ADDENDUM NO. 2

Date:	January 6, 2010		
To:	Contractors		
From:	Wayne Smith – Project Manager		
Reference:	Richfield Armory Upgrade Utah National Guard – Richfield, Utah DFCM Project No. 09219470		
Subject:	**Addendum No. 2**		
Pages	Addendum Cover Sheet	1	page
	Revised Project Schedule	1	page
	Architect's Addendum	16	pages
	Total	18	pages

ADDENDUM #2

PROJECT: Utah National Guard
Richfield Armory Upgrade
Project No. - 09219470
620 W 200 S
Richfield, UT 84701

SUBJECT DETAIL 11/S501 **DESIGNED** BDY **CHECKED** BDY

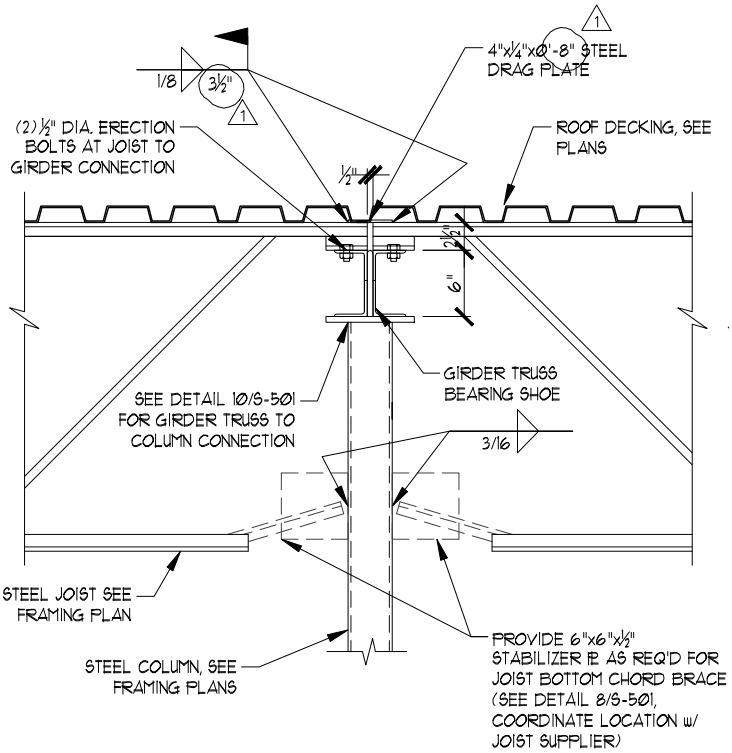
3. SHEET G-008 ACCESSIBILITY DETAILS:
3.1. Details D6: See attached details for revisions to the handrail
4. SHEET S-101 GENERAL NOTES:
4.1. Sheet reissued to go along with comments from Addendum #1.
5. SHEET S-201 FOUNDATION PLAN:
5.1. Sheet reissued to go along with comments from Addendum #1.
6. SHEET S-301 ROOF FRAMING PLAN:
6.1. Sheet reissued to go along with comments from Addendum #1.
7. SHEET S-501 FRAMING DETAILS:
7.1. Detail 11: Replace with the one attached.
8. SHEET S-502 FRAMING DETAILS:
8.1. Sheet reissued to go along with comments from Addendum #1 as a number of details were modified.
9. SHEET S-504 FRAMING DETAILS:
9.1. Detail 6: This new detail is attached and should be added to this sheet.
